P-16093	
35103

NAME	DATE
(JINDAL)	JINDAL ALUMINIUM LTD.	DRAWN	PARVESH	16-01-2017
OVALDOL OF OUR IDA		CHECKED		
SYMBOL OF QUALITY AN ISO 9001 COMPANY	BANGALORE-560073 (INDIA)	APPROVED	B.NATARAJ	A 16-01-2017
1. ALL DIMENSIONS ARE IN mm. 2. ROUND OFF ALL SHARP CORNERS WITH 0.40 mm. 3. TOLERANCES WILL BE AS PER IS:6477-1983 , UNLESS OTHERWISE SPECIFIED		SCALE		1:1
		AREA mi	m²	344.25
		PERIMETER	mm.	201.14
PARTY'S NAME	GENERAL CATEGORY, MUMBAI MARKET	WEIGHT kg/	/m	0.929
		DRAWING	No. S	ECTION No.
PARTY'S DRAWING No.	AS PER REQUIREMENT	P-16093	3 –	
	LIEO WD	35103 35103-ISSUE-3		
ALLOY & TEMPER	HE9 WP			
DESCRIPTION	MISC. SECTION

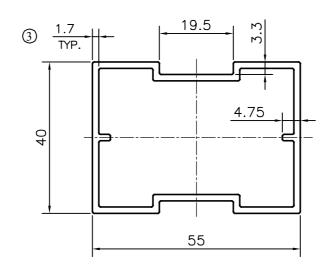
ISSUE-2 THICKNESS CHANGED FROM 1.75 TO 1.57 mm. WEIGHT ALSO CHANGED FROM 0.955 TO 0.862 Kg/m. ISSUE-3 THICKNESS CHANGED FROM 1.57 TO 1.70 mm.

WEIGHT ALSO CHANGED FROM 0.862 TO 0.929 Kg/m.
